ADDENDUM #2

Reference: Monument Valley Vendor Village
Utah Navajo Trust Fund
DFCM Project 03272300

Subject: **Addendum No. 2**

ADDENDUM NUMBER TWO

Item E-1.1: Sheet E-000: Electrical Schedules:

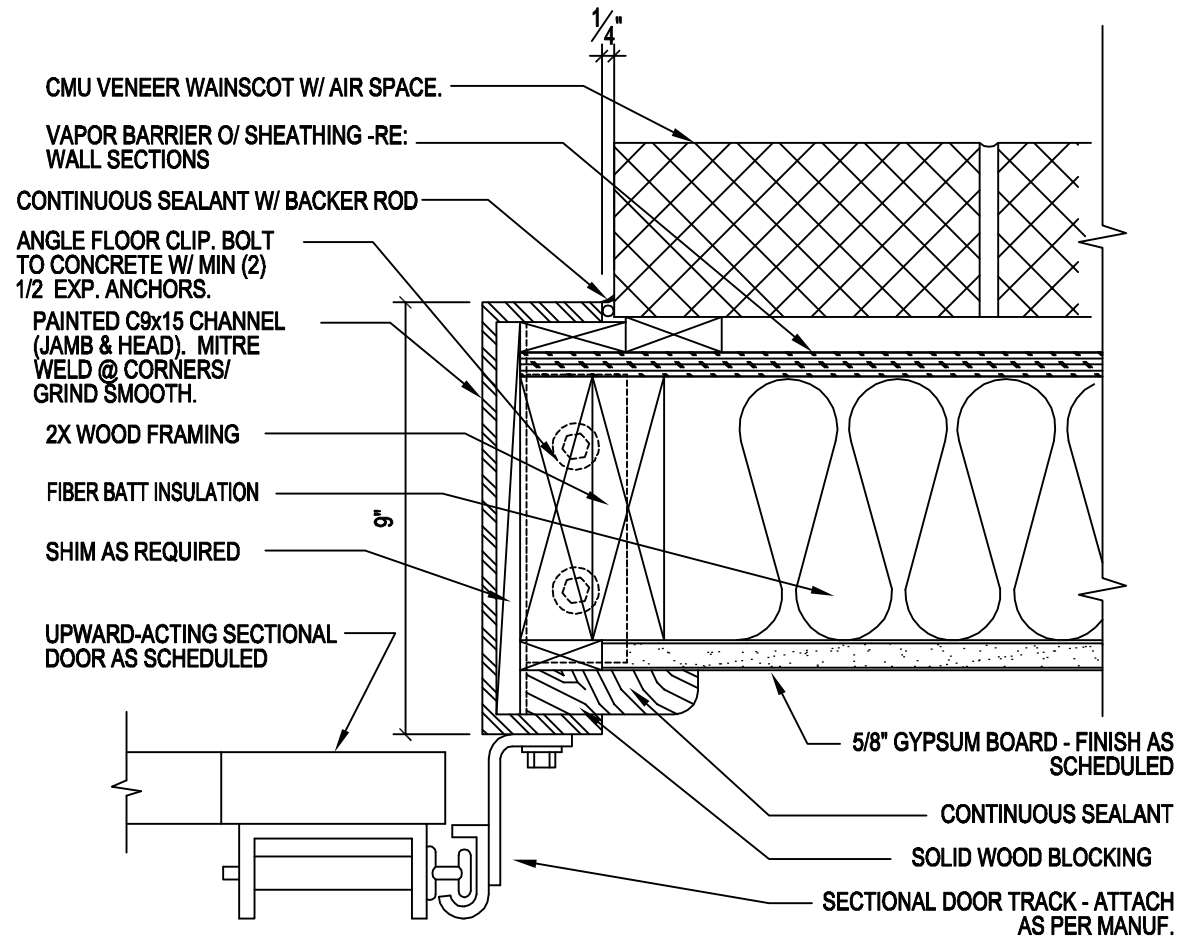
1. Refer to the following list for approved light fixtures.

The following items, trade names, products, and manufactures are approved for bidding. Approval does not relieve the bidder from satisfying the intent of the requirements of the drawings, specifications, and addenda in every respect. Failure to conform to the design quality and standards specified, established, and required may result in later disapproval. If equipment must be disapproved after bidding, supplier shall supply specified equipment at no extra cost to the owner.

11. Regarding Sheet A402

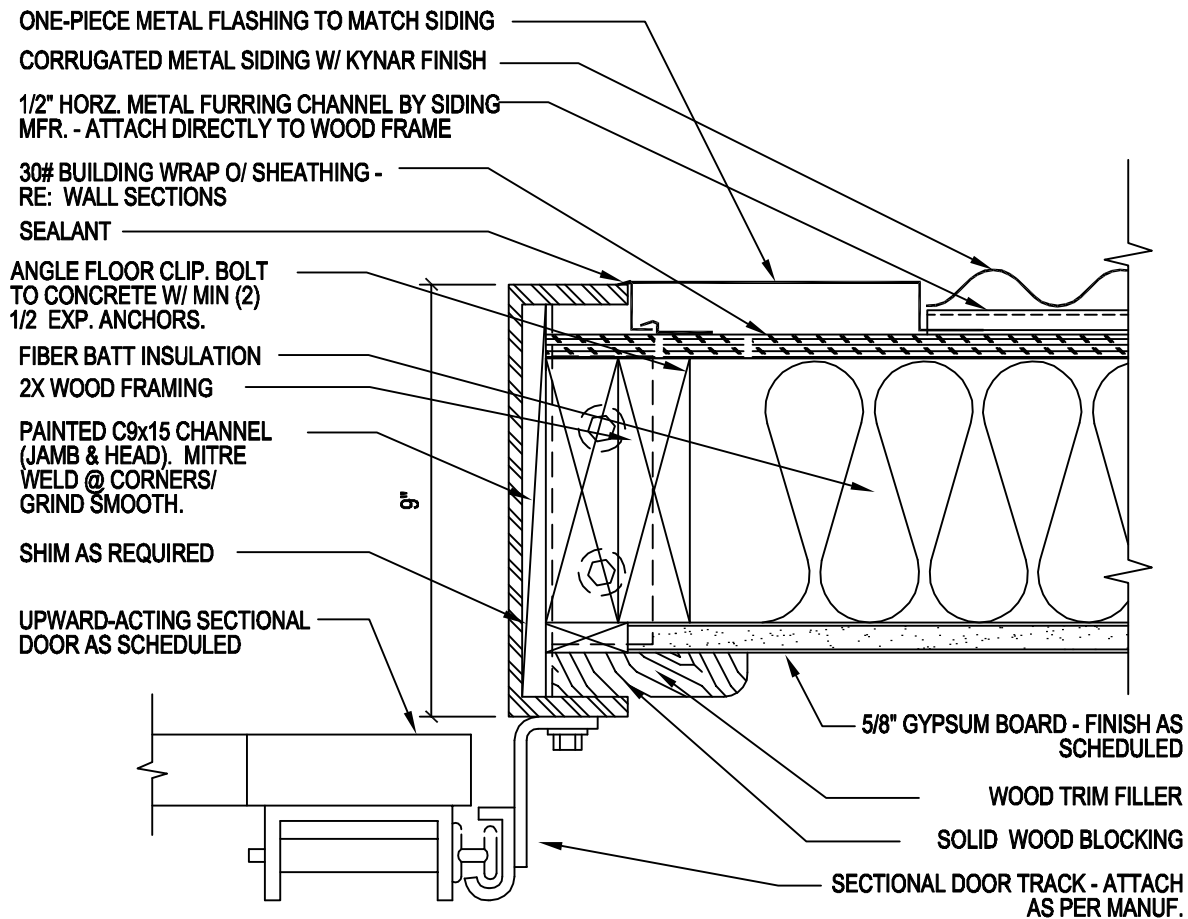
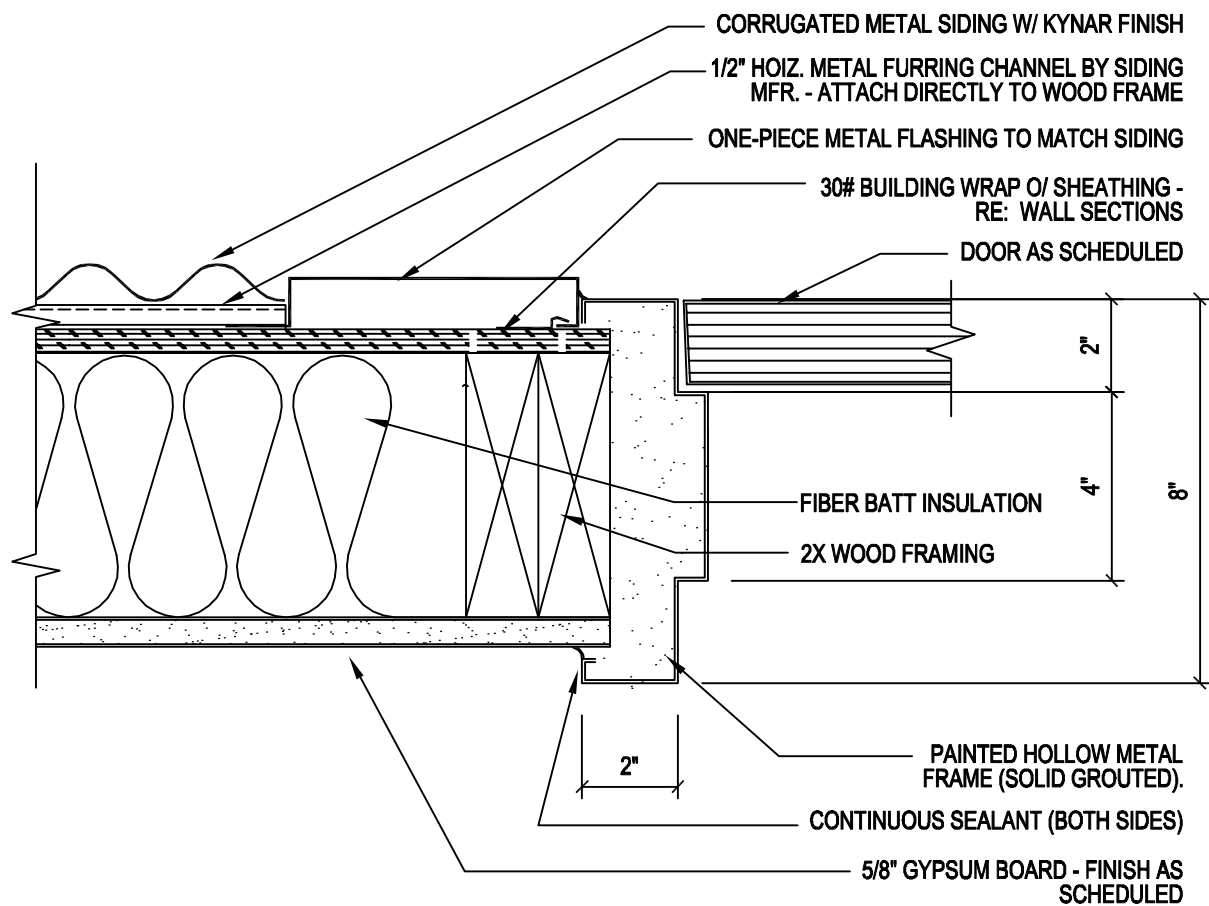
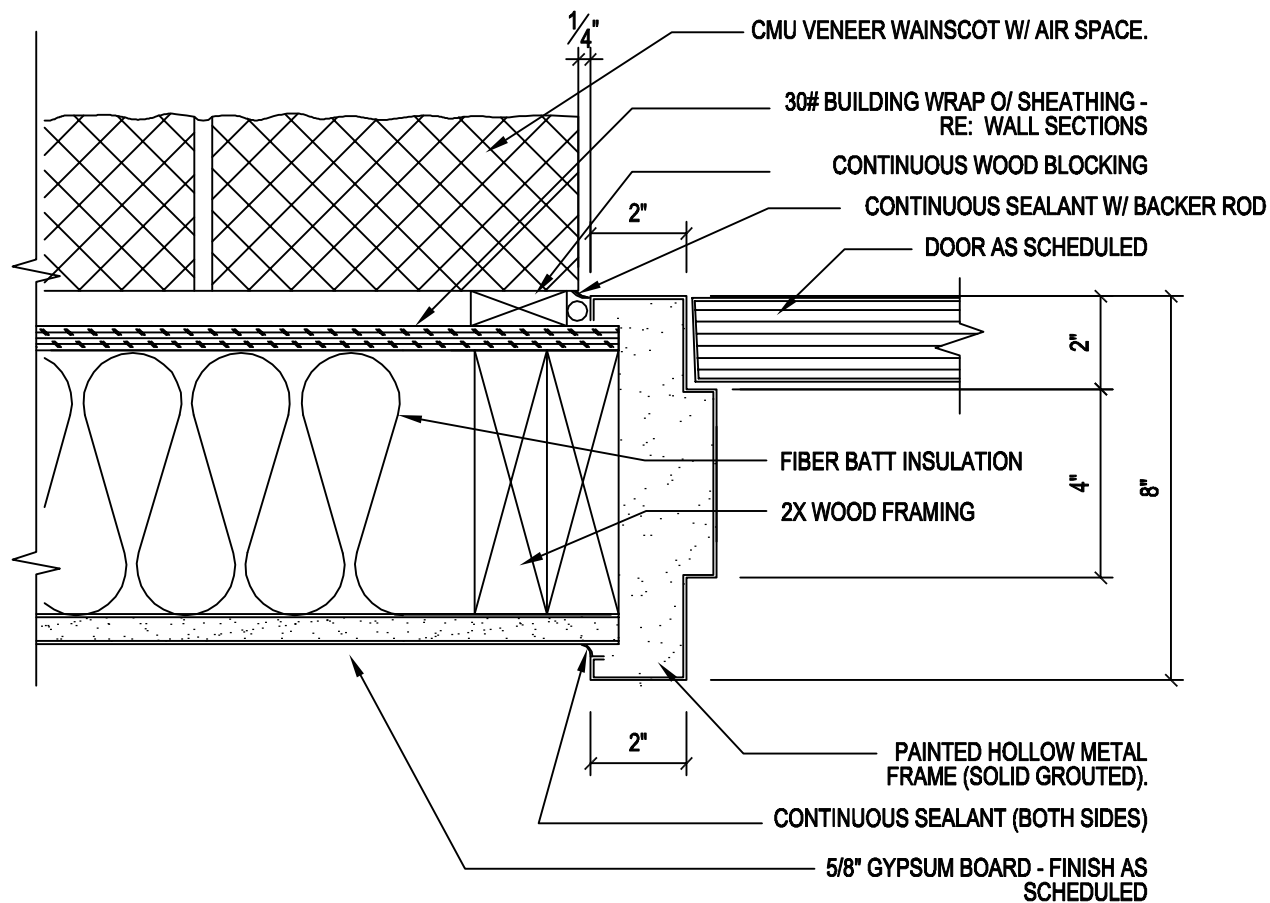
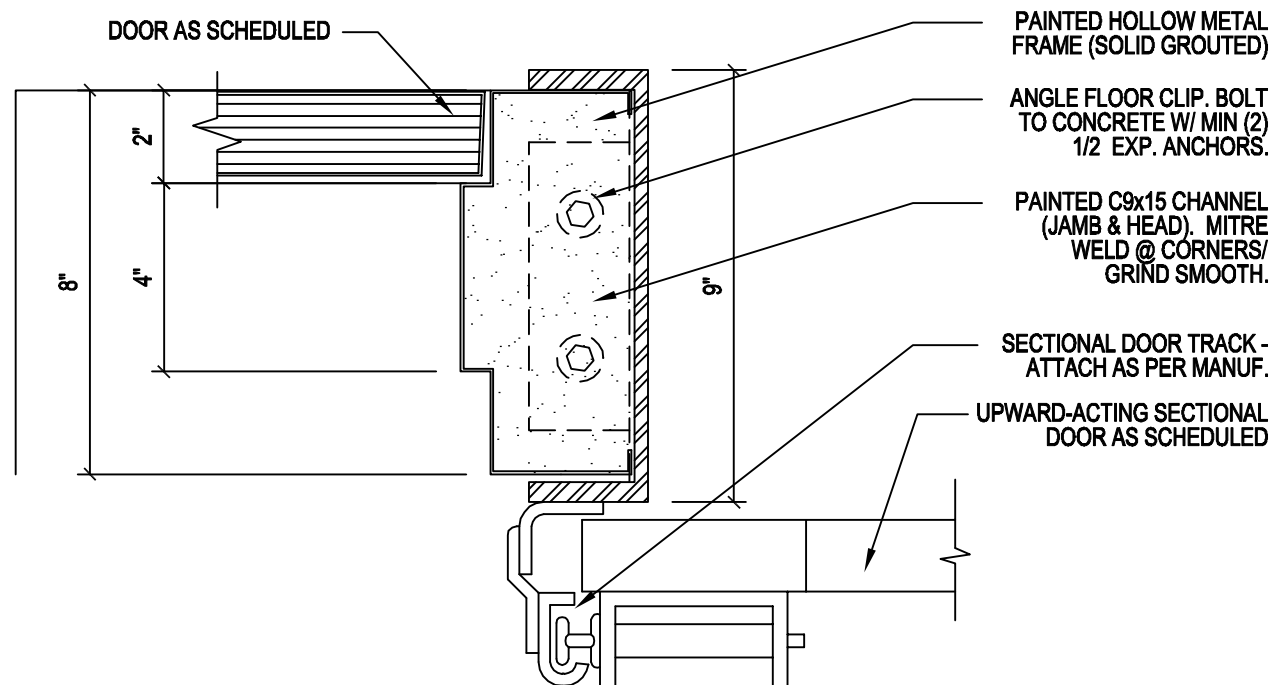
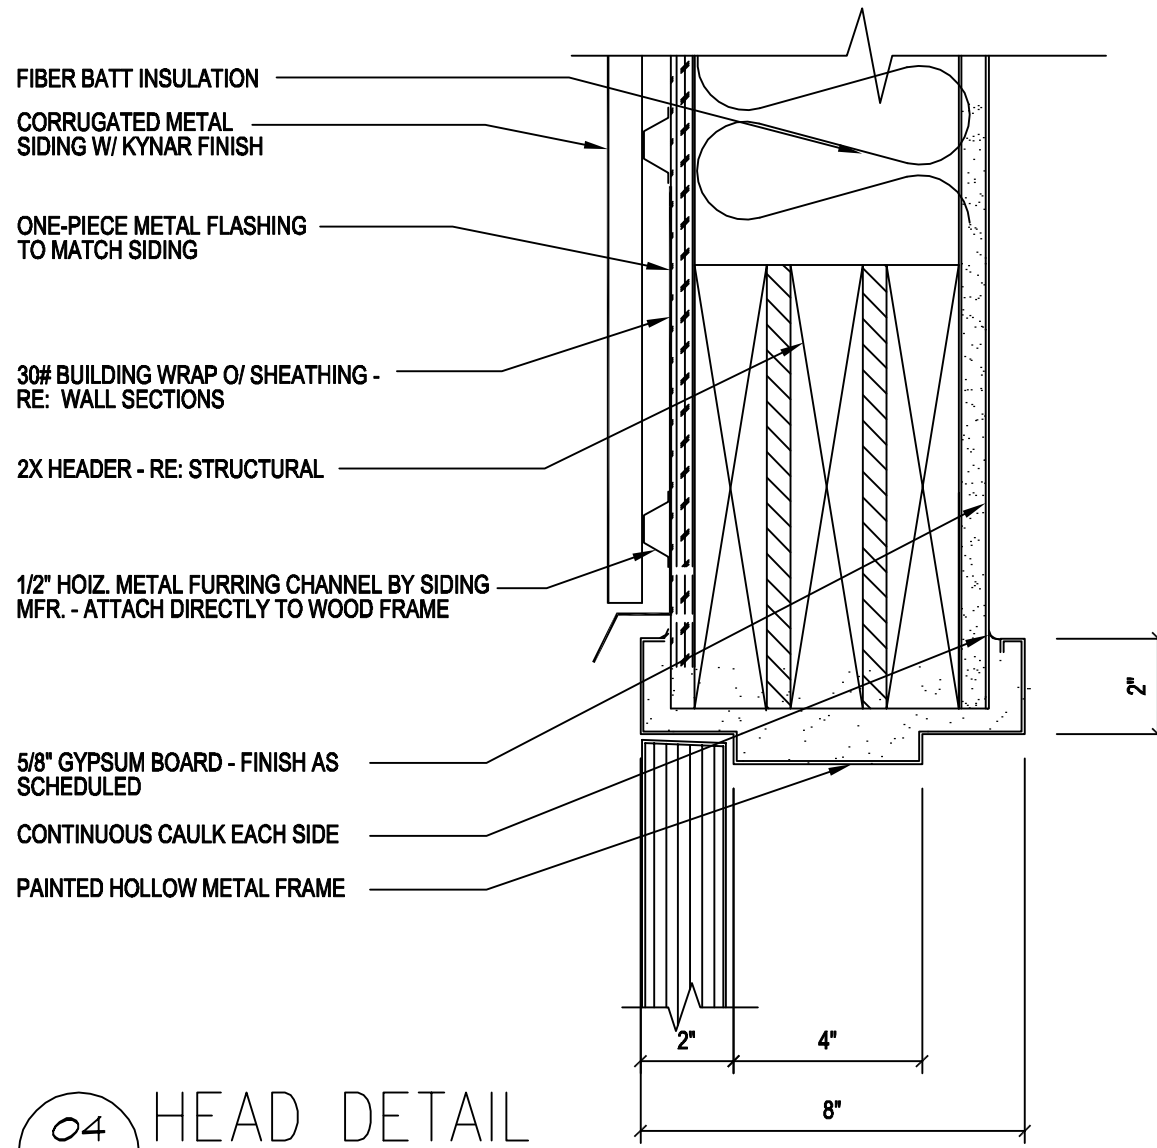
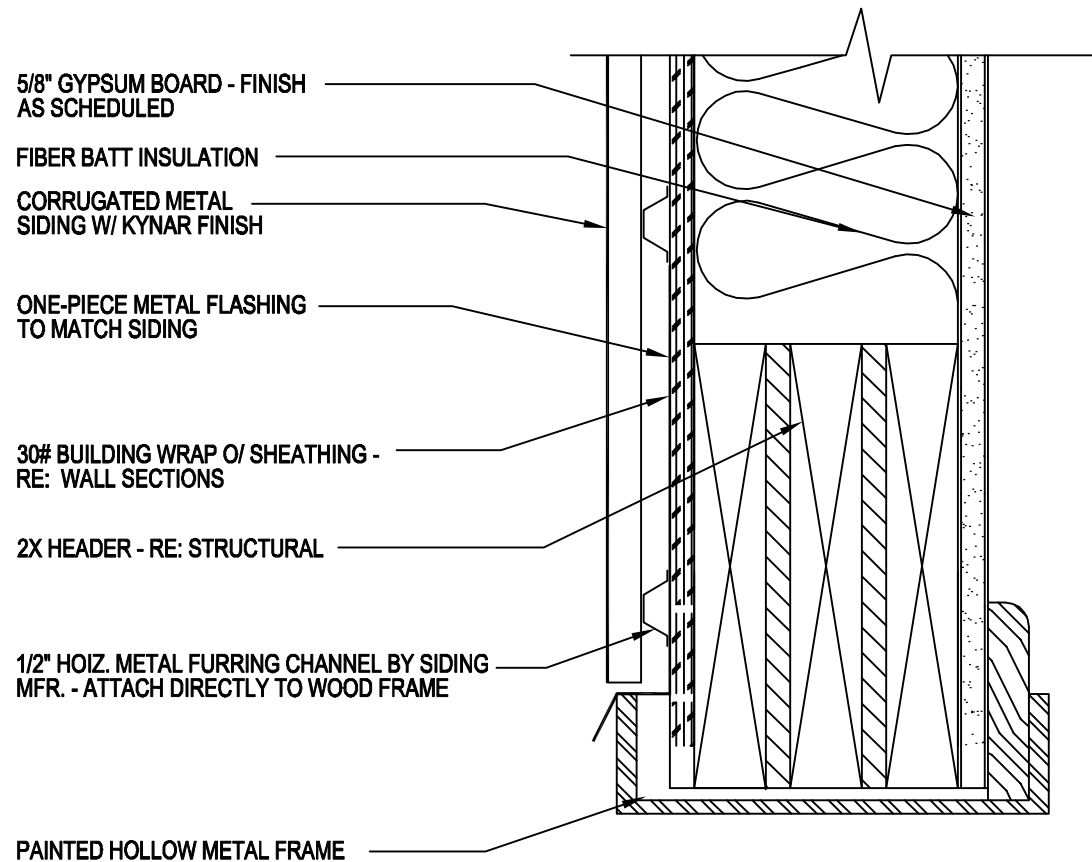
- a. Delete details 01, 02, 03, 04, 05, 06 ,07 and replace using details SD-01a through SD-01g provided as part of this addendum. These details provide a solid structural frame for the overhead rolling doors at each of the vendor positions and change the size of the adjacent hollow metal door frame for the entry doors.
